RNTPC Paper No. A/YL-NSW/250B
 For Consideration by the Rural and
 New Town Planning Committee
On 28.4.2017

APPLICATION NO. A/YL-NSW/250

| <u>Application</u> | Proposed Petrol Filling Station with Sales Office |

繪圖 DRAWING
A-1

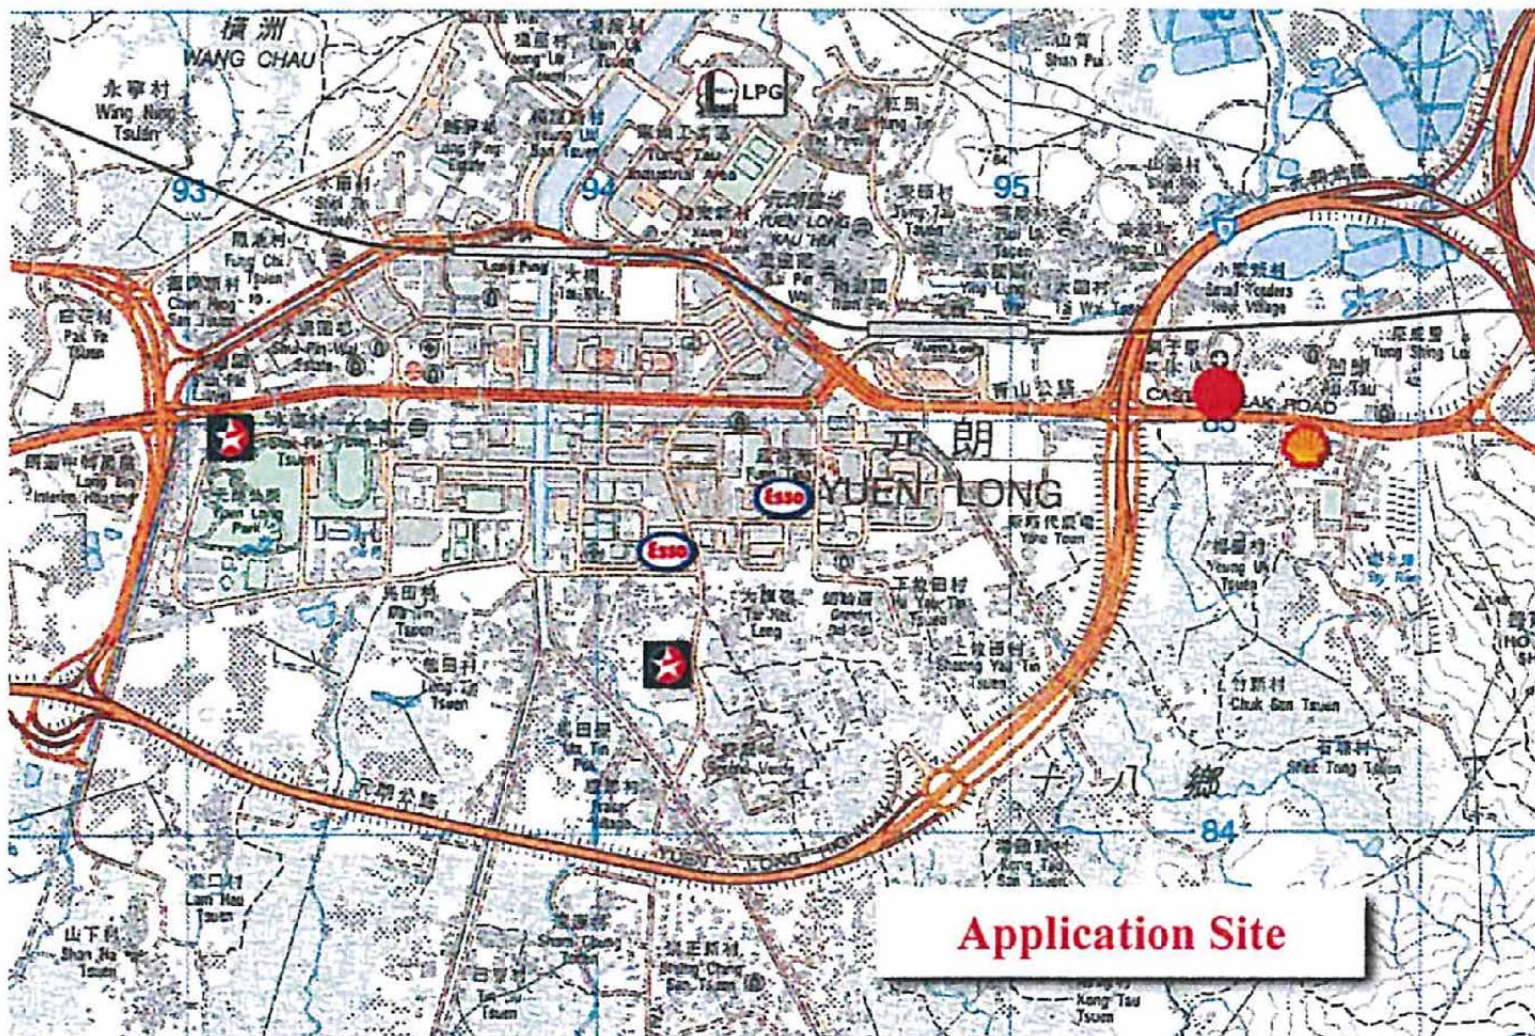
* The only long vehicle permitted to enter the PFS would be the road tanker (about 10m long) which would arrive once daily during non-peak hours. When the road tanker enters the Site, PFS staff will reserve the petrol filling space F1 and waiting space W1 (**Drawing A-1**) in advance to ensure smooth manoeuvring.

繪圖 DRAWING
A-5

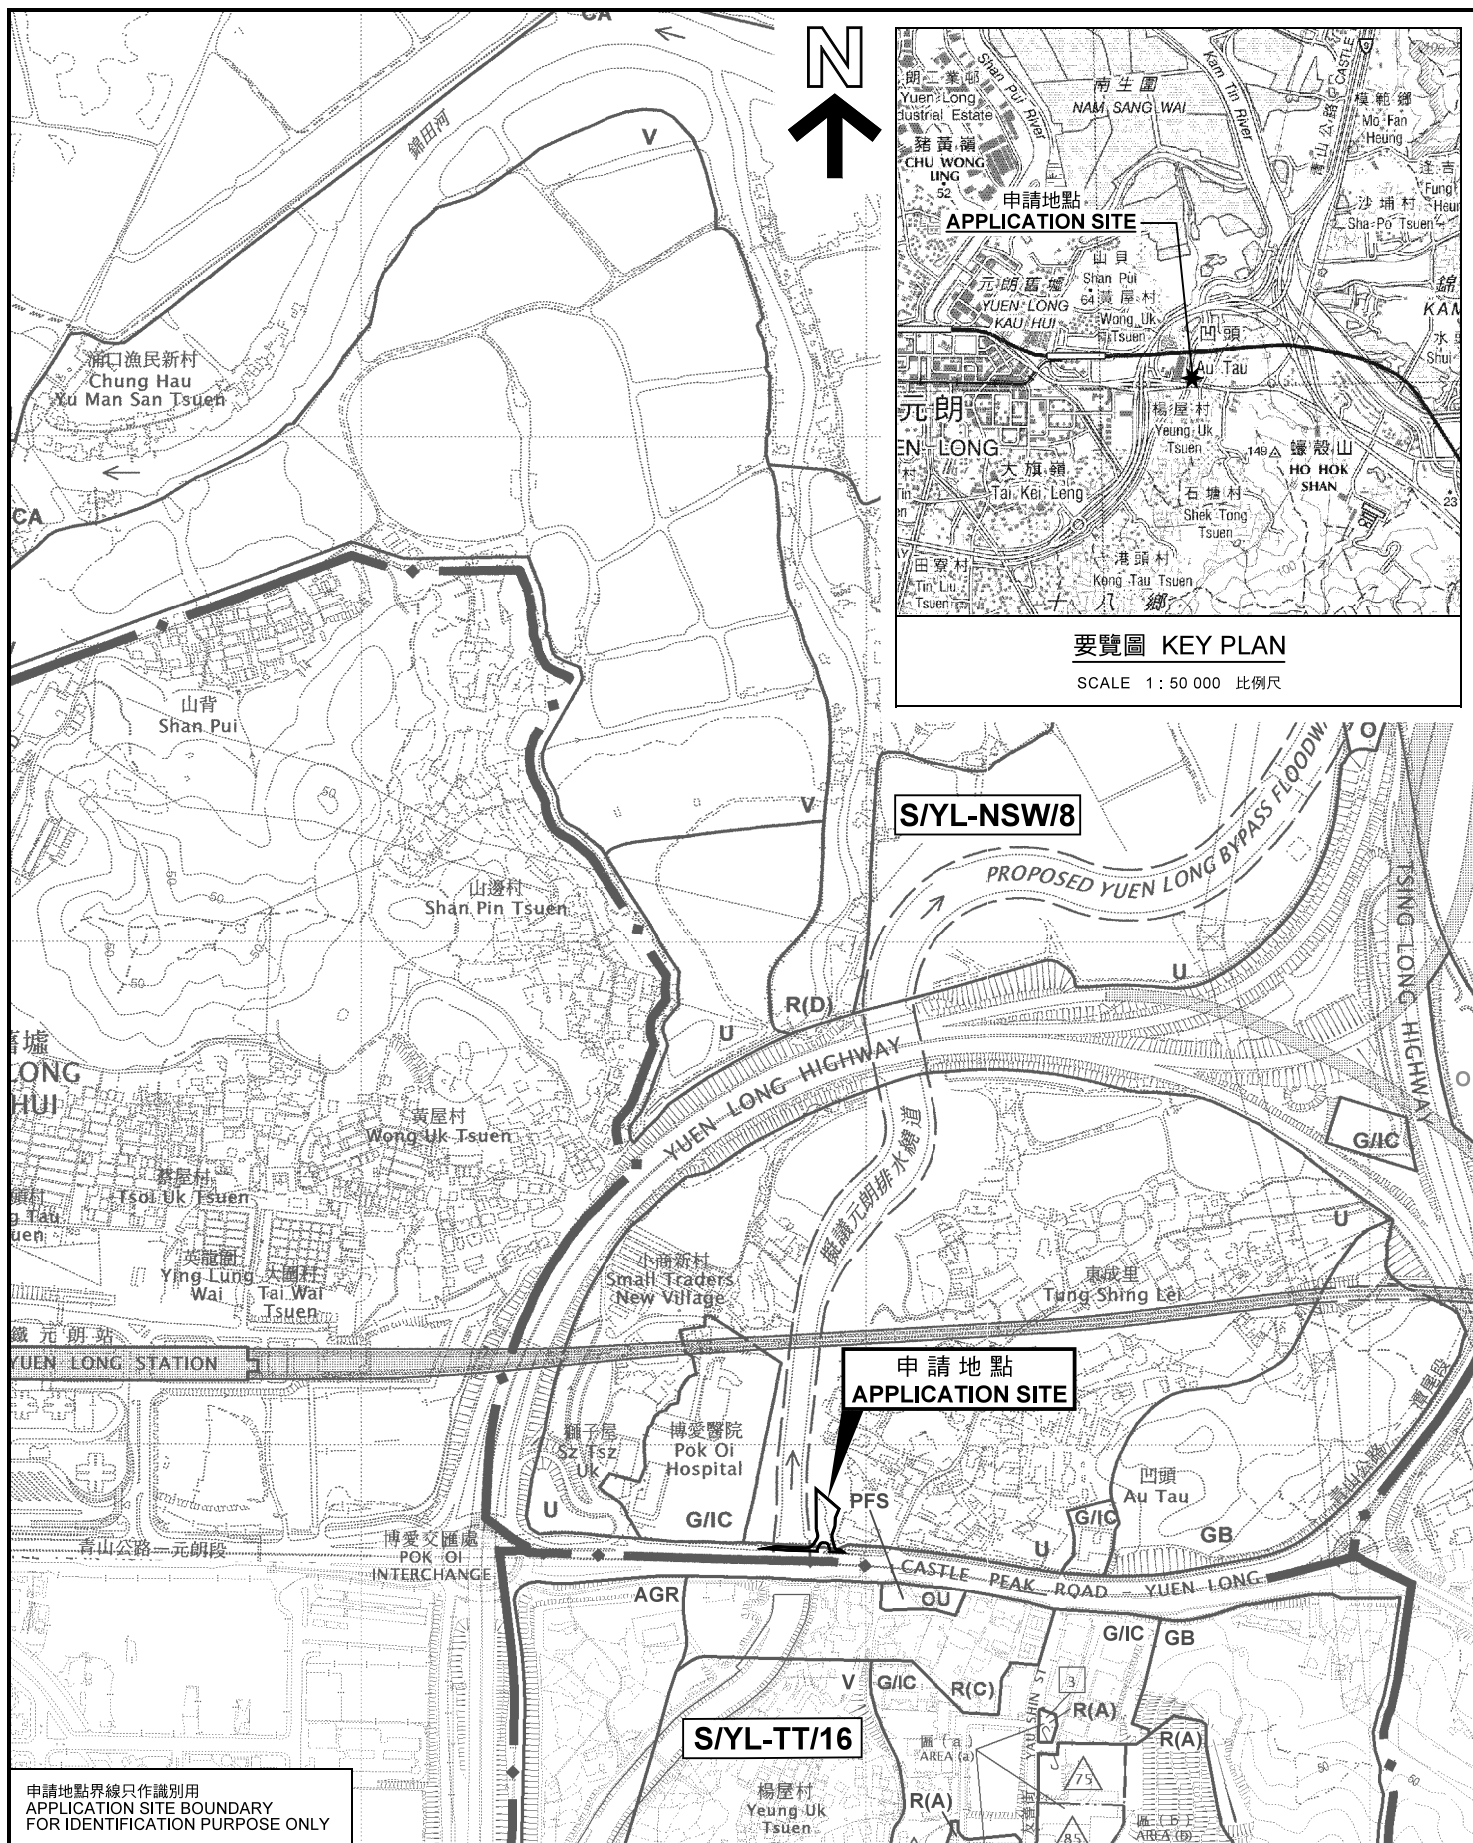
- (a) He has no comment on the need of PFS.
- (b) The applicant has proposed about 70m-long existing cycle track to be converted to footpath and carriageway to form the run in/run out/access of the proposed PFS (**Drawings A-1, A-5 and Plan A-2**). The applicant should explore re-provisioning of cycle track so as to maintain the cycle track continuity.
- (c) In view that the applicant has not satisfactorily addressed his comment regarding the re-provisioning of the cycle track, he could not support the application at this stage from traffic engineering perspective.
- (d) The proposed vehicular access serves only the Site. C for T would not take up its traffic management. In this regard, the applicant has confirmed to take up the management and maintenance responsibility of the proposed vehicular access (merging and diverging lanes).

- (a) A substantial section of cycle track (about 70m) will be affected and has to be converted to footpath and access/ingress/egress to the development. This section of cycle track was just widened by CEDD under Contract No. YL/2013/01 and handed over to TD/HyD for management/maintenance on 11.10.2016. As such proposal may attract potential complaint from cyclists, further comment from CEDD and TD should be sought.
